SORELL PLANNING AUTHORITY (SPA) AGENDA

6 AUGUST 2024

5.1 SUBDIVISION APPLICATION NO. DA 2023 / 9 - 1

Applicant:	PDA Pty Ltd
Proposal:	Eight Lot Subdivision
Site Address:	16-42 Arthur Highway, Dunalley including works to the Arthur Highway road reservation (CT 206181/1)
Planning Scheme:	<i>Tasmanian Planning Scheme - Sorell</i>
Application Status	Discretionary
Relevant Legislation:	Section 57 of the <i>Land Use Planning and Approvals Act 1993</i> (LUPAA) & Part 3 of the <i>Local Government (Building and Miscellaneous Provisions) Act 1993</i> (LGBMP).
Reason for SPA meeting:	Subdivision creates more than one lot. More than one representation received.

Figure 5. Easements (Extract of 2 Ryans Road title)

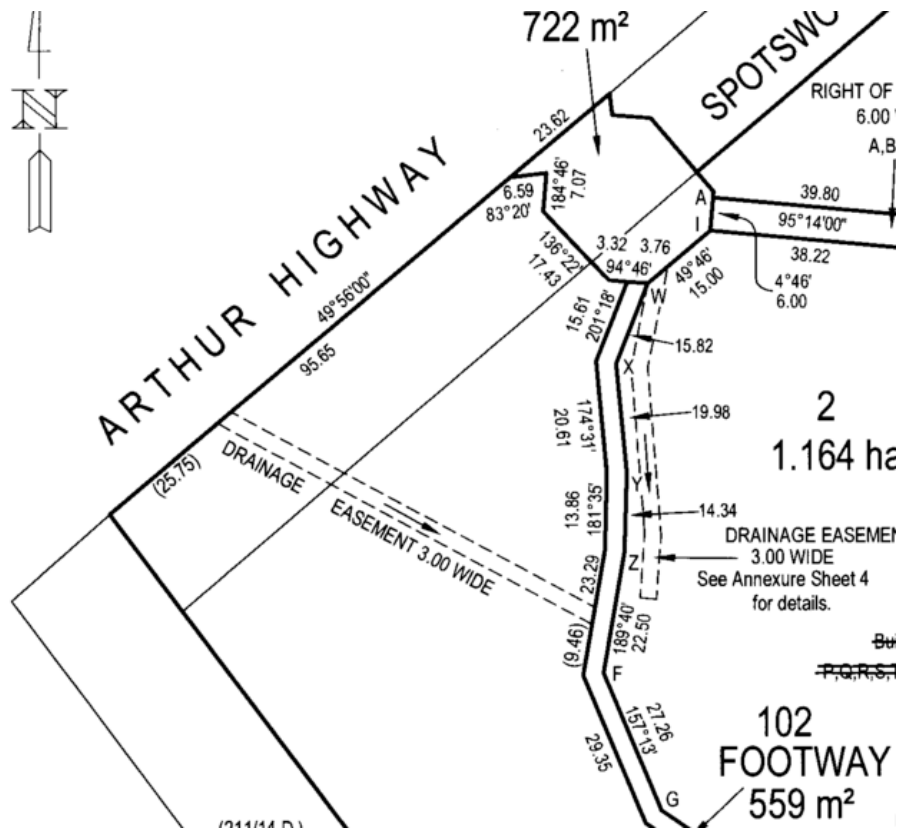
Both open drains required by the Ryans Lane subdivision appear at face value to be contained within drainage easements shown in figure 5 (a survey would be required to confirm).

Both easements were created through the Ryan's Lane subdivision and registered in 2013. Both drainage easements incorrectly benefit Sorell Council as opposed to the Department of State Growth, however, this is of no consequence to their function or legality. On this point it is important to note that the easements related to pre-existing natural runoff.

Figure 11. Flood Hazard Area Overlay along Frontage of Lots 1 and 2

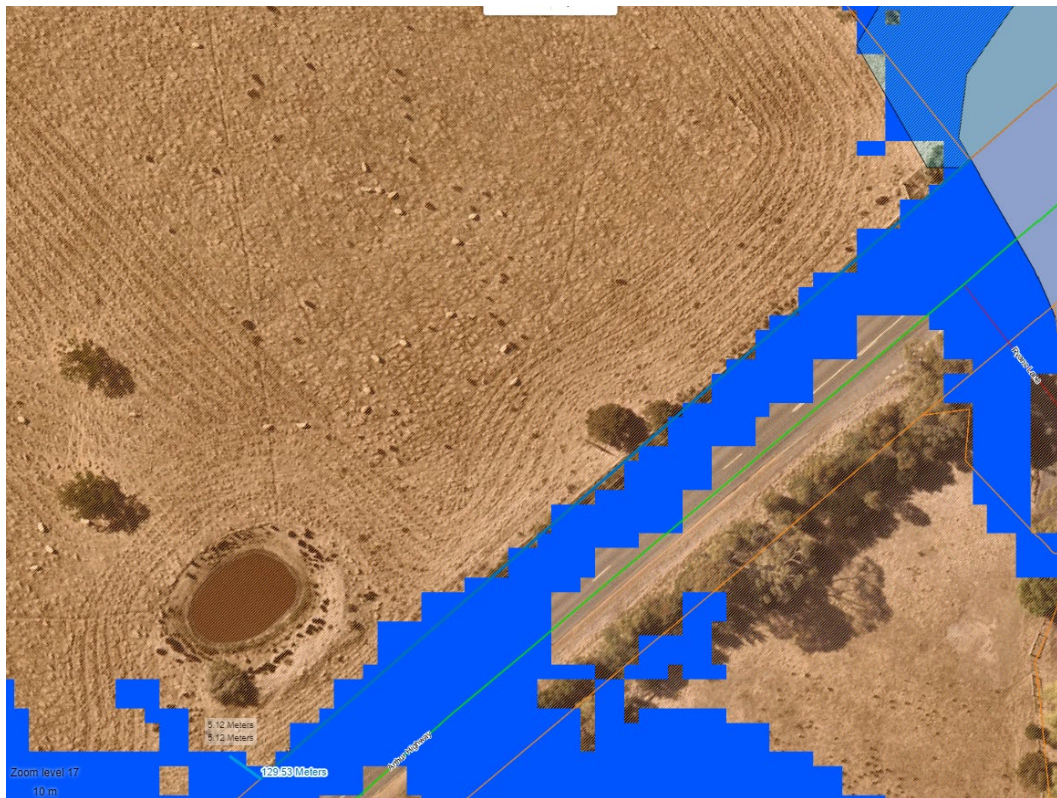
The extent of flooding along the frontage of lots 1 and 2 is shown in figure 11. The modelling indicates that during a 1% AEP event, the culverts are undersized and flooding occurs on the northern side of the highway, including overtopping the highway in two places. For lot 1 and lot 2 there are sections of frontage entirely clear of flood hazard, however, as shown in figure 12 the accesses are partially subject to the overlay. Detailed flood mapping shows that at no point along the frontage does the depth of flooding exceed 0.2m.

- the accesses will not increase the flood risk to any adjacent land;
- the level of risk, in terms of the severity of the hazard and the consequence to life and property of a partially flooded access at a minimal depth, is slight.

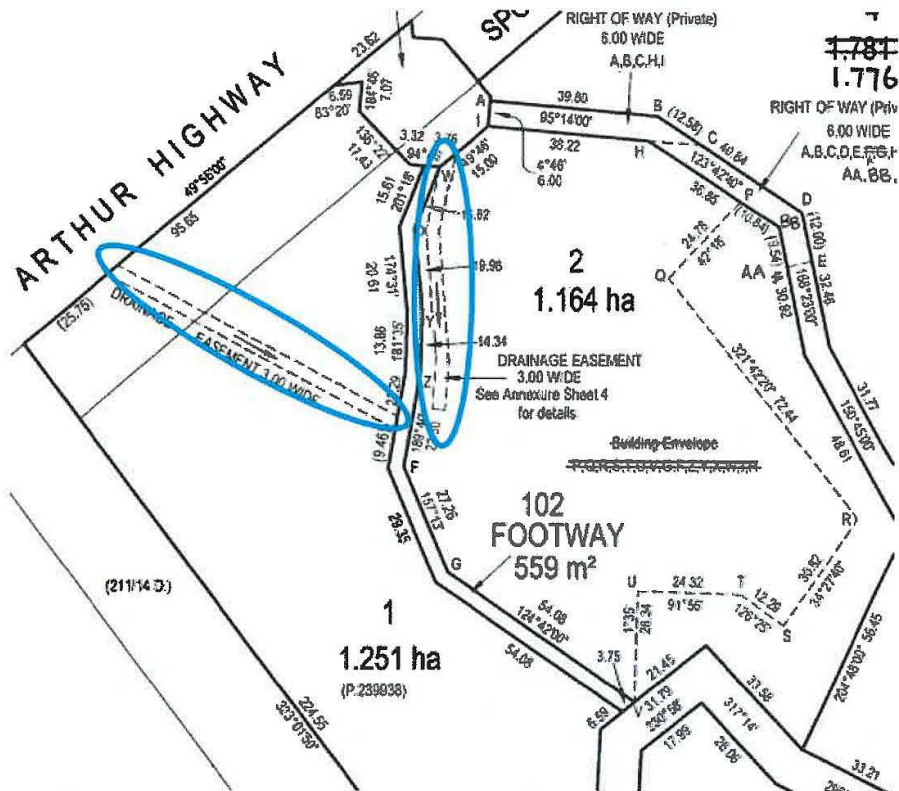
I note that the above extracted image does not match the depiction of the flood-prone hazard area shown on the plan of subdivision. The above extract from the electronic mapping is to be taken to prevail over that shown by the applicant.

It is noted that cl.C12.7.1 P1 requires that each lot not create an opportunity for use or development that cannot achieve a tolerable risk from flood. At present, lot 3 has its vehicle access located through an area that is mapped to be flood-prone, and then internally will require that access/driveway to cross further flood-prone hazard areas to provide access to the building area that is shown for the lot. The application does not indicate whether and how this can be managed.
